APPLICABILITY: 2020-23MY Outback & Legacy With 2.4L DIT
2019-23MY Ascent

NUMBER: 09-106-23R

SUBJECT: Exhaust Pipe Front (EPF) Design Change

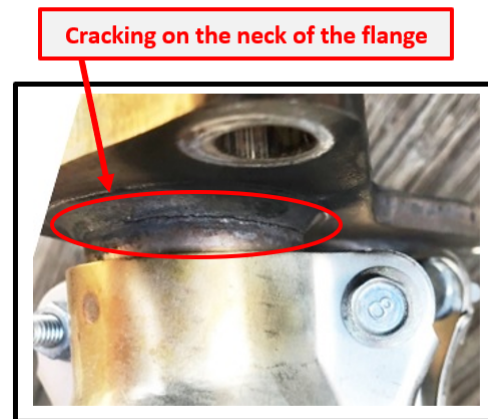
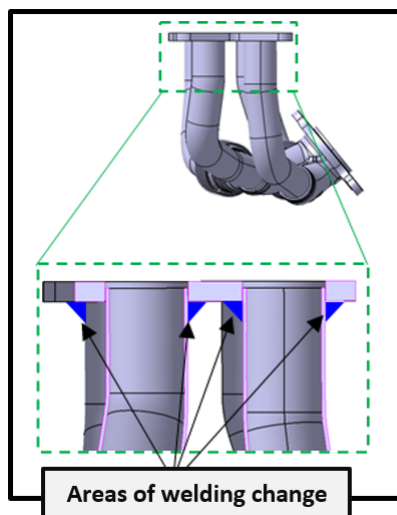
This bulletin announces design changes made to the Exhaust Pipe Front (EPF) to address concerns of rattle-type or fluttering sounds coming from the undercarriage during acceleration caused by cracking in the EPF. A welding material with enhanced durability has been incorporated into the production of the EPF. If the condition described is confirmed, the EPF should be inspected and if determined necessary, replaced.
